DCP/NRC1232  
NSD-NRC-98-5543  
Docket No.: 52-003

SUBJECT: AP600 RESPONSE TO FSER OPEN ITEMS

Enclosure to Westinghouse  
Letter DCP/NRC1232

Large I Beams

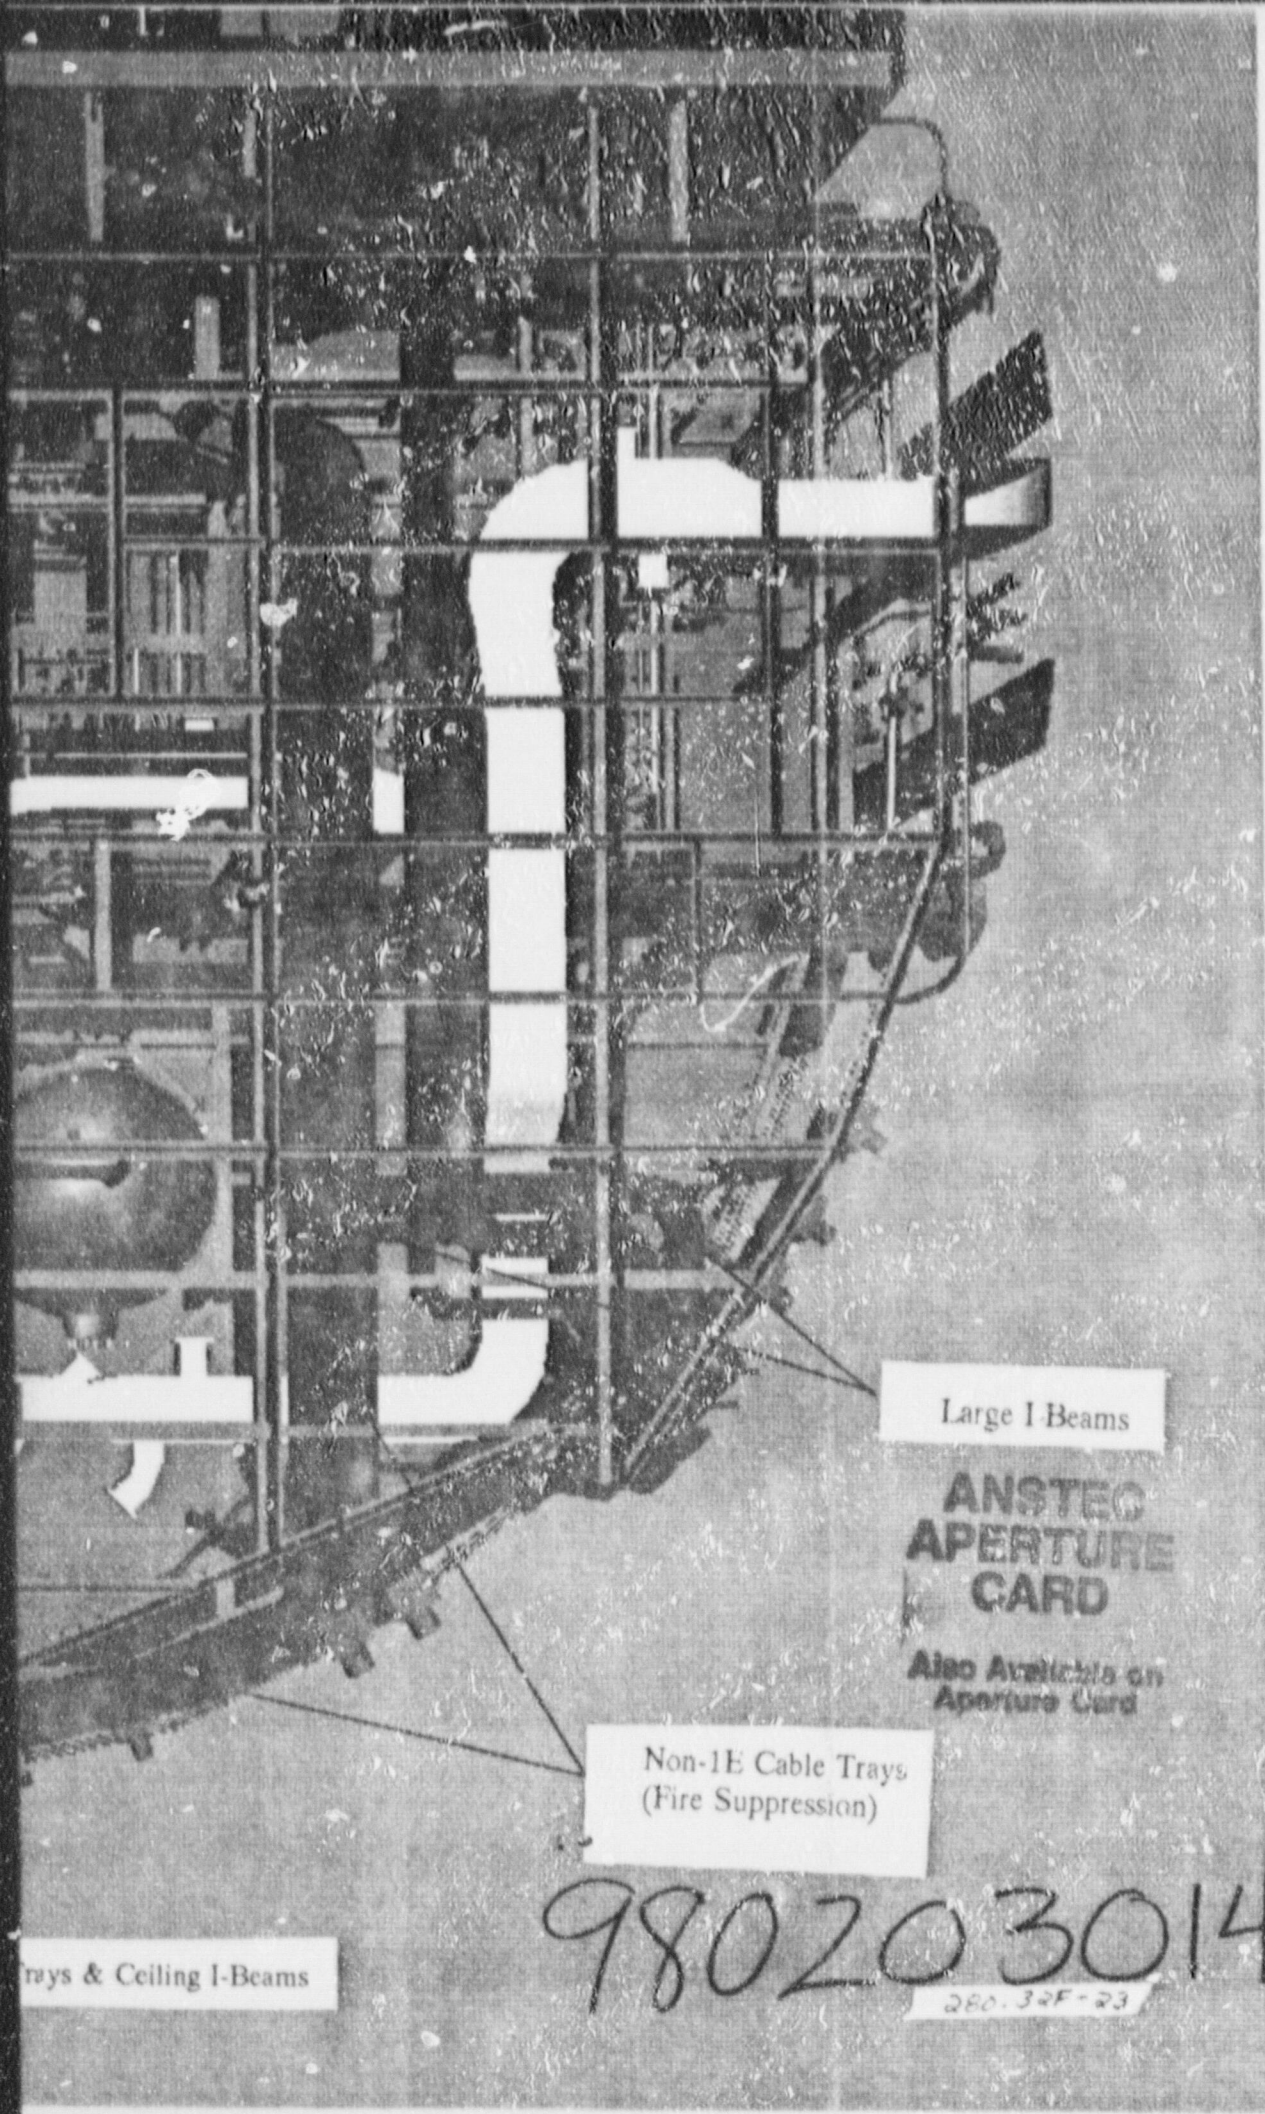
Figure 3 shows the large vents through the roof of zones 11300A/B. Figure 4 shows cable trays in the 11300B fire zone. Note that the safety-related cable trays are enclosed types. The nonsafety-related cable trays are open types. The division B/D cable trays in zone 11399S will be enclosed by noncombustible barriers made of steel or steel composite materials. The limited amount of combustibles located in this zone together with its high ceiling and large volume indicate that it would not heat up rapidly. Hot gases from a fire in the cable tray area will rise away from the cable trays and exit to the upper containment volume above operating deck. These hot gasses are impeded from crossing over from zone 11300B to 11300A by the large I-beams that support the concrete operating deck (see Figure 4). Some of these I-beams are about 3 feet deep. If some hot

gas is not vented to the upper containment volume and works its way past the I-beams under the operating deck, it would be vented up to the upper containment volume through the large vents in the operating deck in zone 11300A (see Figure 3). Note that safety-related equipment is not located near the ceiling of these two fire zones. Also note that safety-related equipment located inside containment is qualified for elevated temperatures of 340 F. As a result, safety-related equipment located in 11300A or 11300B would not see elevated temperatures from a fire in the other zone that would exceed their environmental conditions.

Figure 480.873-1

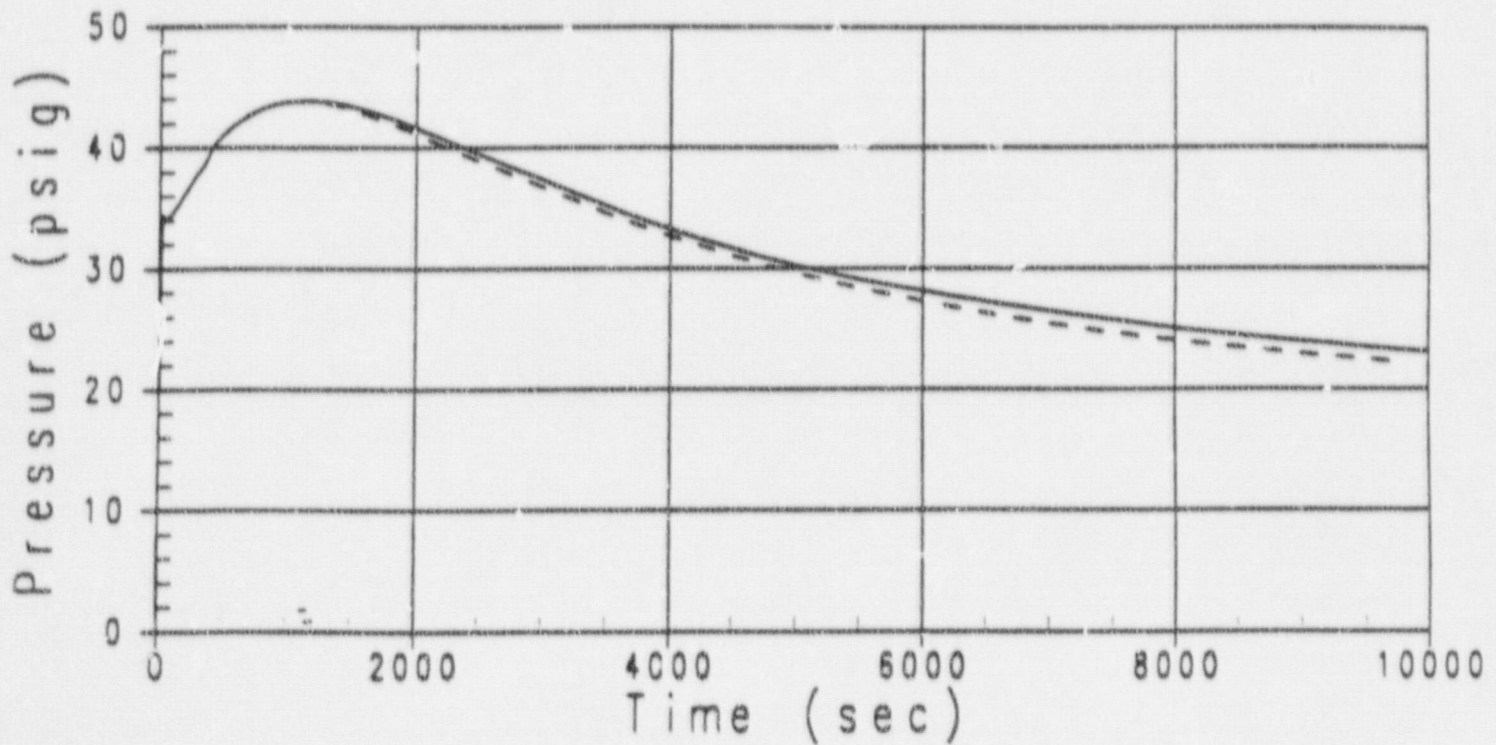
in the original RAI the staff requested Westinghouse provide analyses using the actual PCS flow rates not the limited evaporated flow rates to confirm that the two are identical or at least prove that the evaporated flow model is clearly conservative. The issues are identified in our interim FSER provided you on 12/31/97.

If Westinghouse does not provide these analyses to demonstrate that the two results are identical (as claimed) or that the evaporated flow model is clearly conservative, then we will apply (an as yet undetermined) penalty on the final SSAR pressure results. Both the LOCA and MSLB must be analyzed through the peak pressure period since the PCS is credited for both events.

Sensitivity cases for the LOCA and MSLB pressure response were made using the actual PCS flow rate, instead of the evaporation limited PCS flow rate, in the WGOTHIC AP600 Containment Evaluation Model. Except for the PCS flow, these cases were run with the model described in Reference 480.873-1.
